## CSP 25-056 AL BP041 – ADDENDUM No.01 HVAC MEP EAST ZONE 3

Fort Bend Independent School District  
2023 Bond Program

Addendum 01

13 August 2025

SC-M3.00

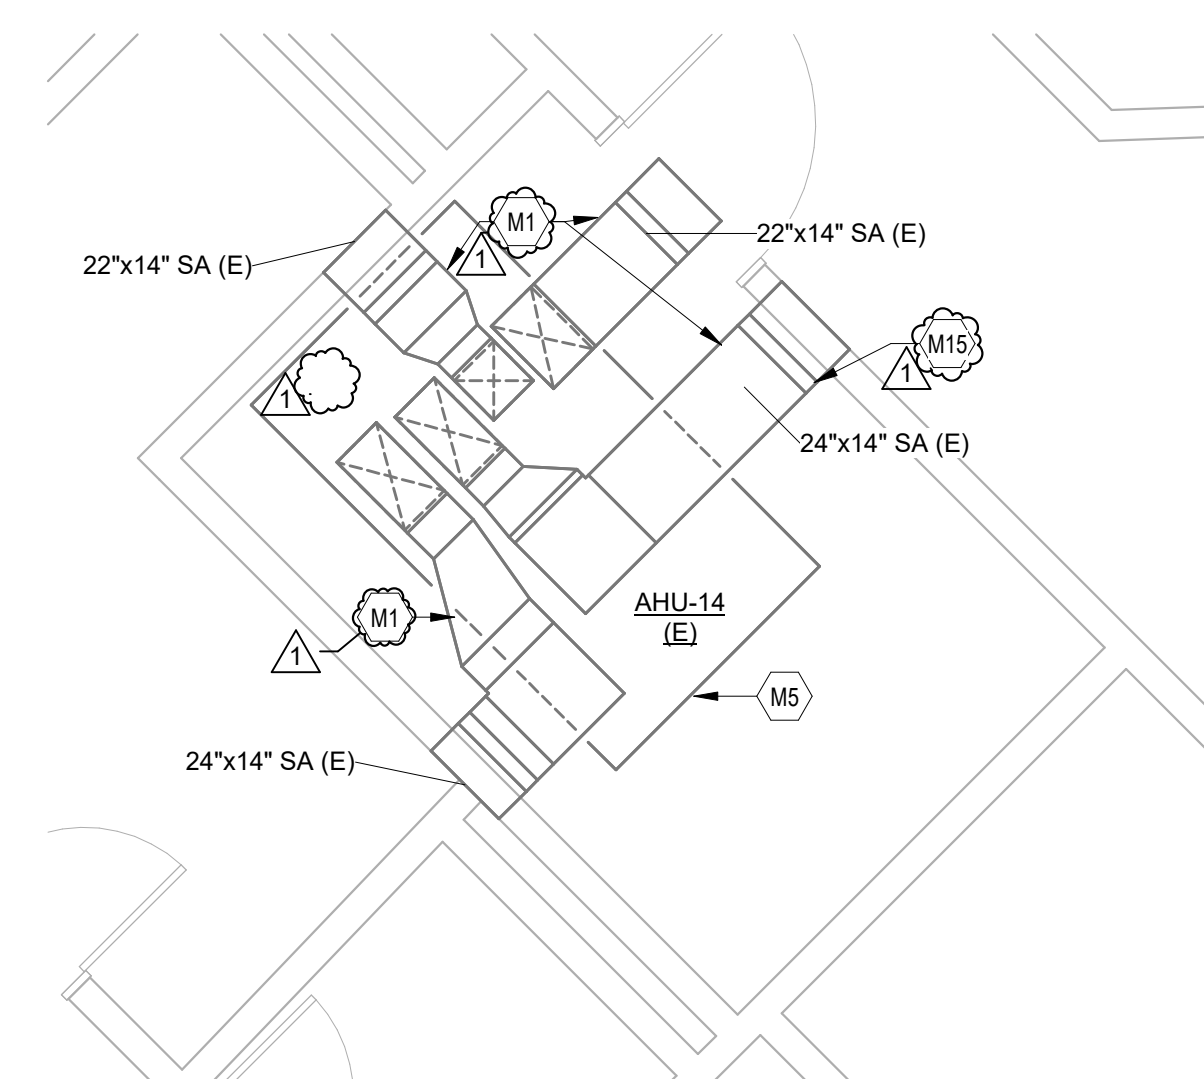
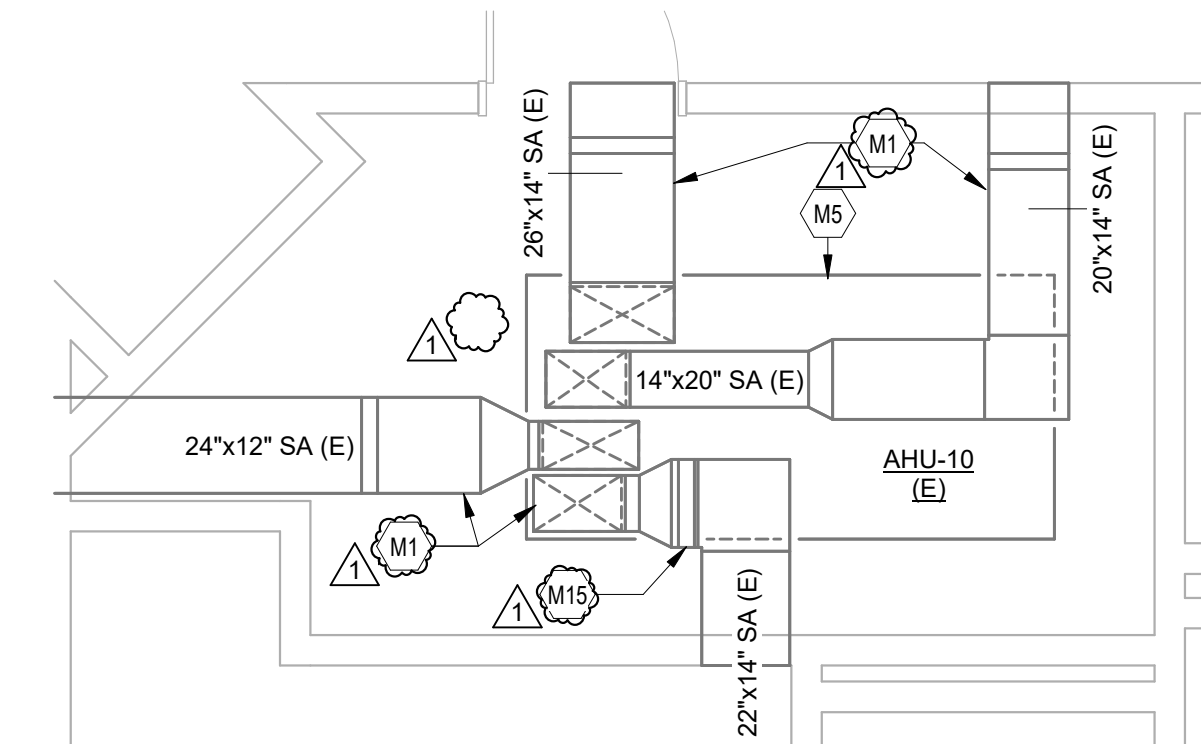
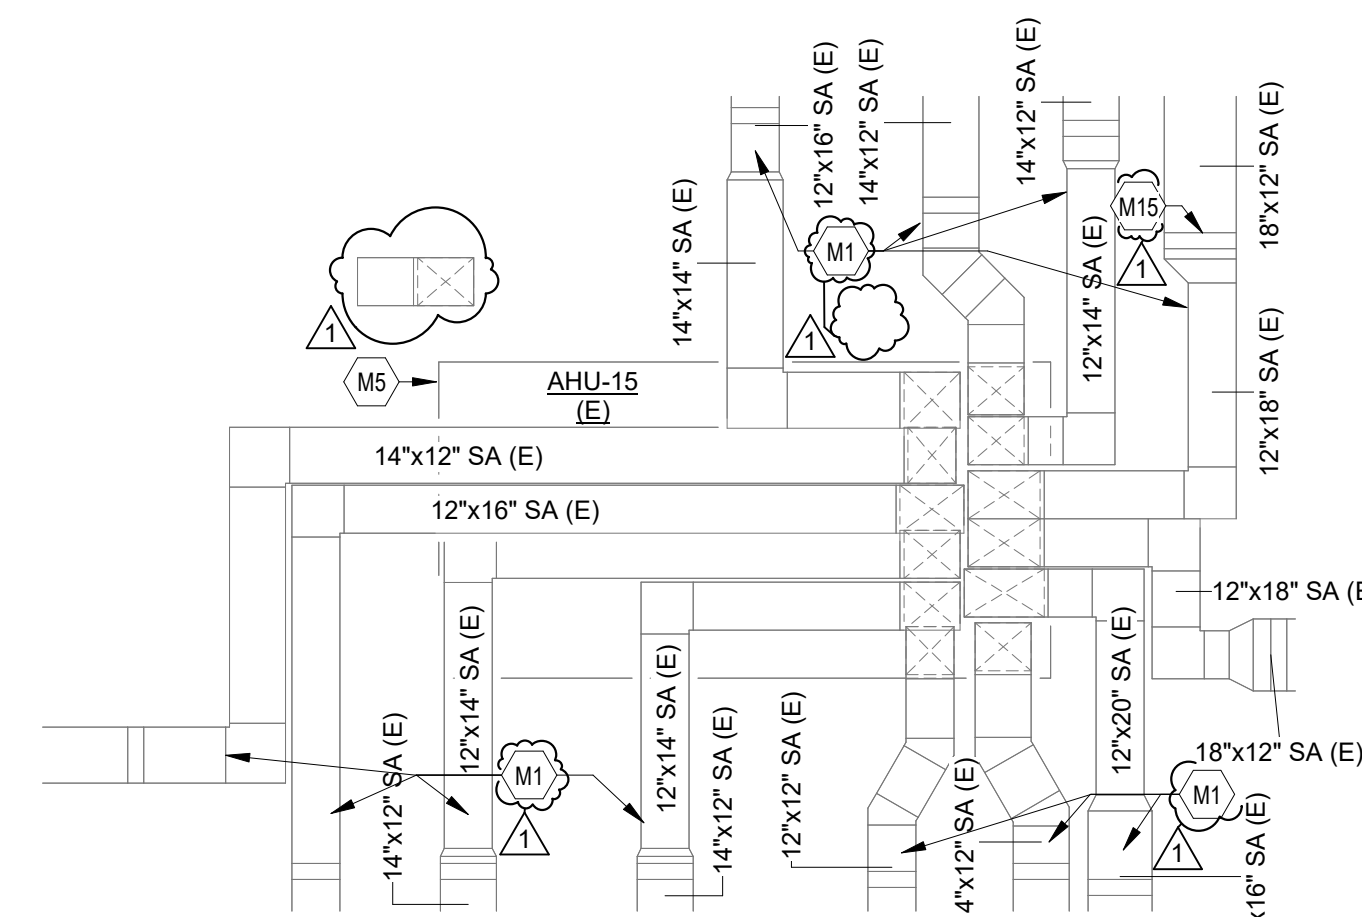
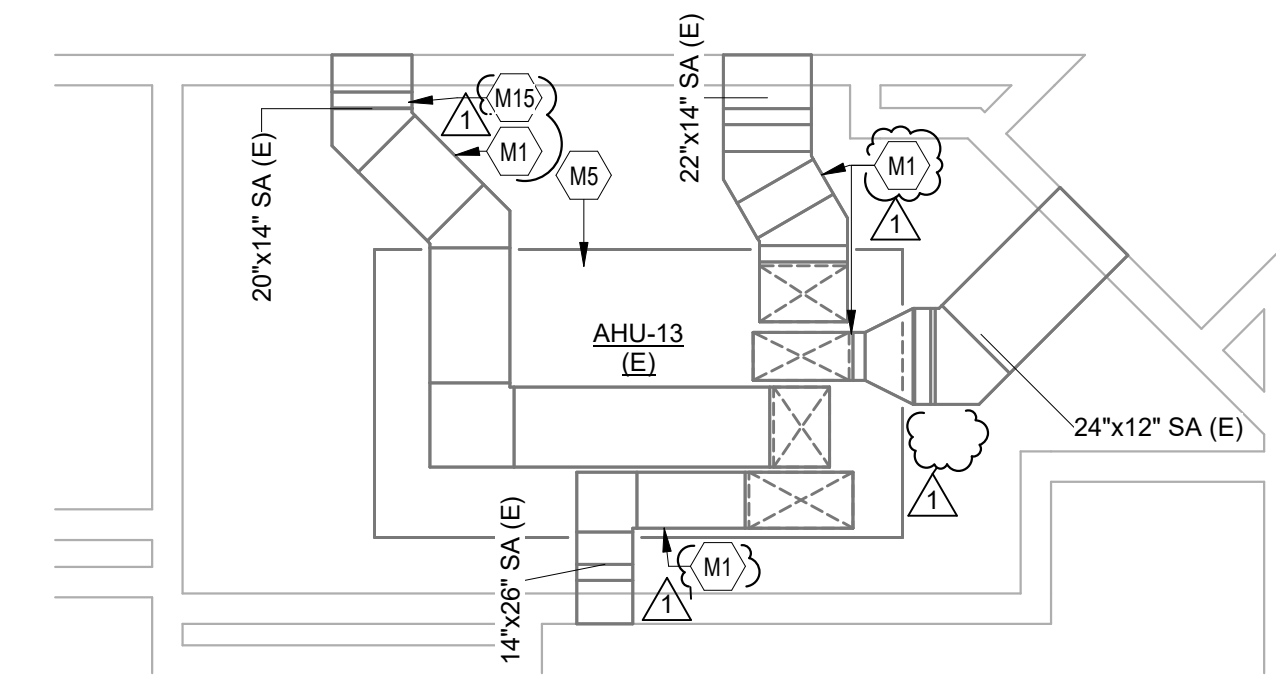
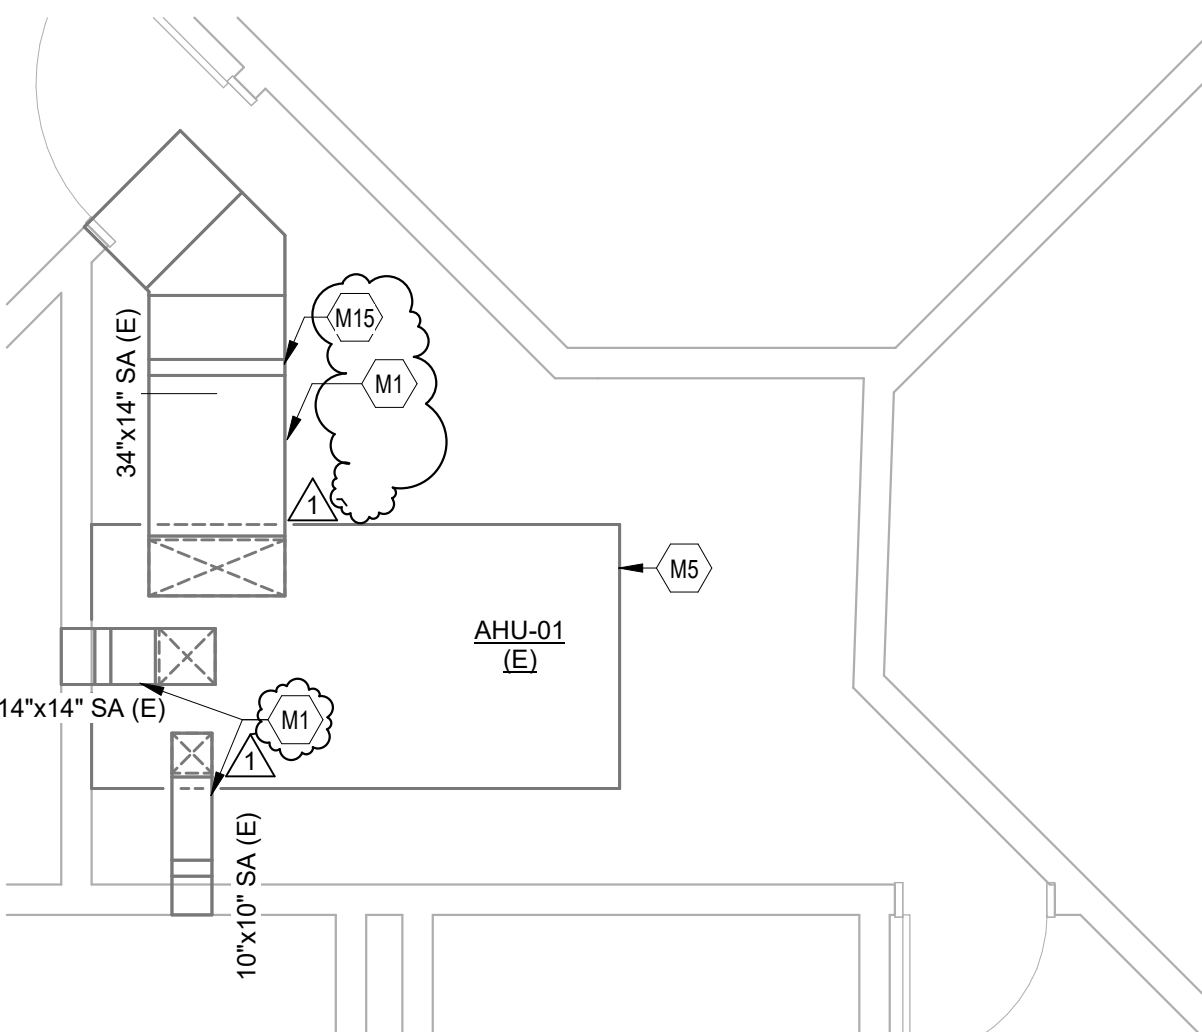
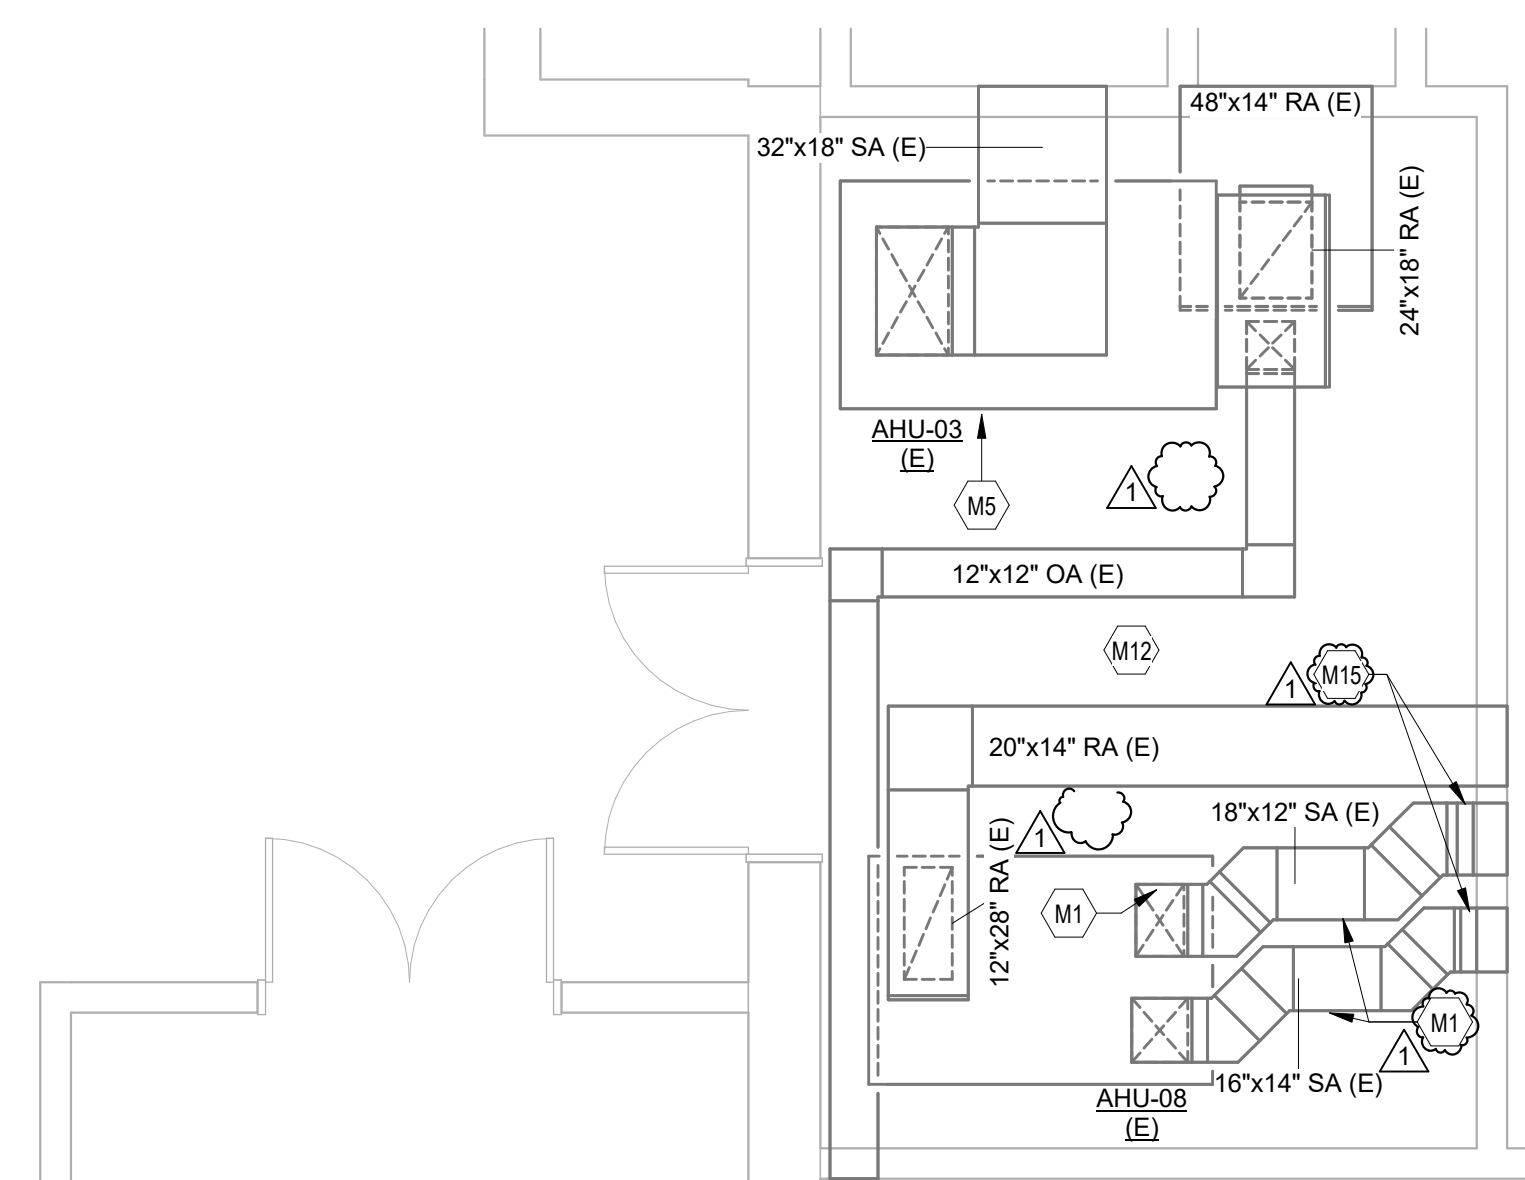
- 04 **Sheet SC-M3.00 – ENLARGED PLANS**
  - a. Removed Keynote M1: “install access panels on supply and return ducts or plenums. Locate access panel on an easily accessible location. Size panel to be 30” by duct width, minus four inches...” in all mechanical rooms.

- b. Replaced M1 in new location addressing duct heaters. Changed M1: “Install access panel on supply duct upstream of hydronic duct heater...”
  - c. Added keynote for existing duct heater to remain.

TAGGED NOTES	
M1	INSTALL ACCESS PANEL ON SUPPLY DUCT UPSTREAM OF HYDRON DUCT HEATER. LOCATE ACCESS PANEL ON AN EASILY ACCESSIBLE LOCATION. SIZE PANEL TO BE 30" BY DUCT WIDTH, MINUS FOUR INCHES. IF DUCT IS WIDER THAN 34", SIZE ACCESS PANEL UP TO 30"x30". REFER TO SPECIFICATIONS FOR UNIT PRICING.
M5	EXISTING AIR HANDLING UNITS AND DUCTWORK TO REMAIN (TYPICAL).
M12	PROVIDE SPRINKLER PIPING INSULATION IN EXTERIOR MECHANICAL ROOMS.
M15	EXISTING DUCT HEATER TO REMAIN (TYPICAL).
